**Re: Response to Request for Additional Information – 41 Broadarrow Road, Narwee (D-503/2018)**

## 41 Broadarrow Road, Narwee – D-503/2018

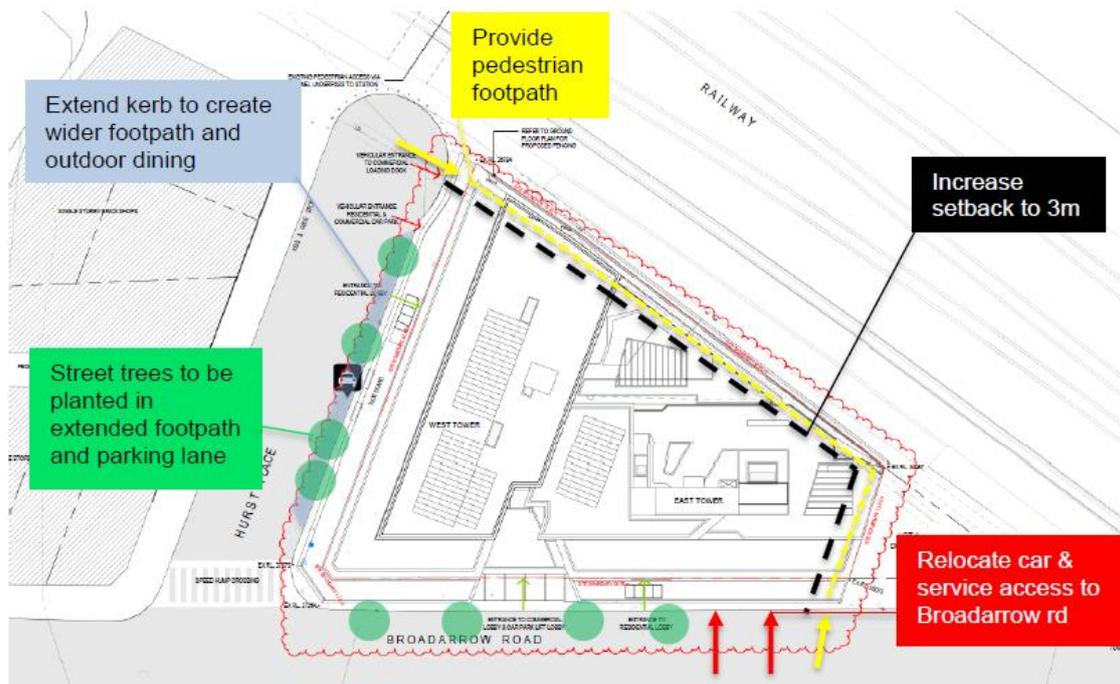
*In addition, this centre forms part of council's Liveable Centres program where upgrades will be occurring to the public domain during 2021 to create pedestrian and cycle friendlier streets. Upgrades will include street furniture, road narrowing to reduce the length of the raised pedestrian crossings, landscaped garden beds to the street edge and street tree plantings. These upgrades need to be discussed with the applicant and considered in the proposal (as a contribution made by the developer either in kind or financially) as it is likely they will occur prior to the remediation of the site.*

*Council would like to discuss an option to extend the footpath by approximately 1m into the street along Hurst Place, to create a wider area for outdoor dining for the restaurants as well as providing street tree planting. The ground floor retail frontage to Hurst Place should maximise activity at the public/private interface through inclusion of bi-fold doors and/or service window/s to the restaurants.*

*The interface to Broadarrow Road is generally supported. However, street trees are required to Broadarrow Road, installing these trees will create an opportunity for an area of landscape planting at the ground level. To avoid conflict with the building's awning, Council will support tree planting in the parking lane. Refer below for an indicative solution to be discussed as part of the liveable centres.*

The balance of the issues raised in the comment relate to works in Council's road reserve. Council's plans and desires for works on that land are matters for Council and not the applicant.

It is further noted that the indicative street tree planting in the Broadarrow Road frontage conflicts with waste collection supported by Council's waste management team. The comment provided by urban design reinforces that centre masterplanning requires a holistic approach and should not be implemented incrementally by disjointed considerations. If an upgrade plan for the Narwee public domain is proposed this should be developed and implemented in the appropriate manner.
